**NEW WAREHOUSE BUILDING
EASTERN CONNECTICUT STATE UNIVERSITY
Willimantic, CT
PROJECT: BI- RW-319**

BID OPENING	1:00 P.M.	July 11, 2012
ADDENDUM NUMBER 1	DATE OF ADDENDUM	July 10, 2012

SK-A1

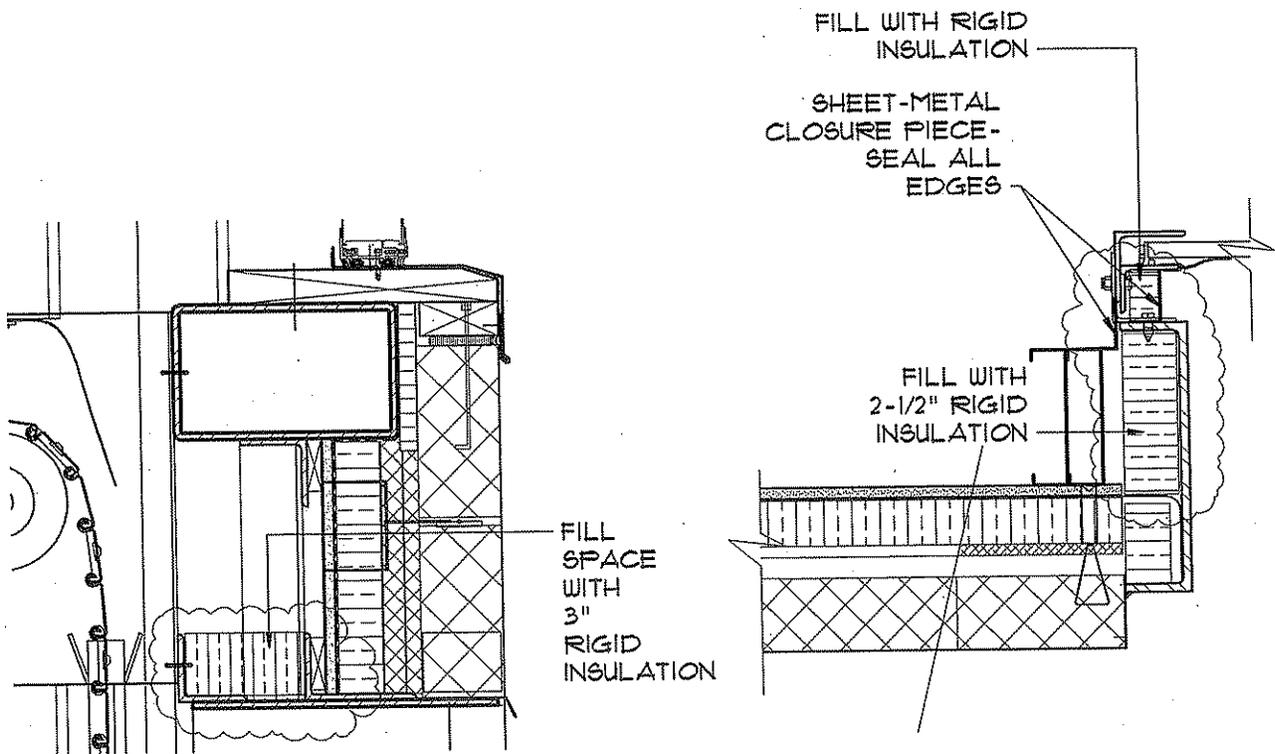
a- **Detail 6/A-301- include additional insulation requirements per SKA-1.**

a- **Detail 6/a-401- include addition insulation requirements per SKA-1.**
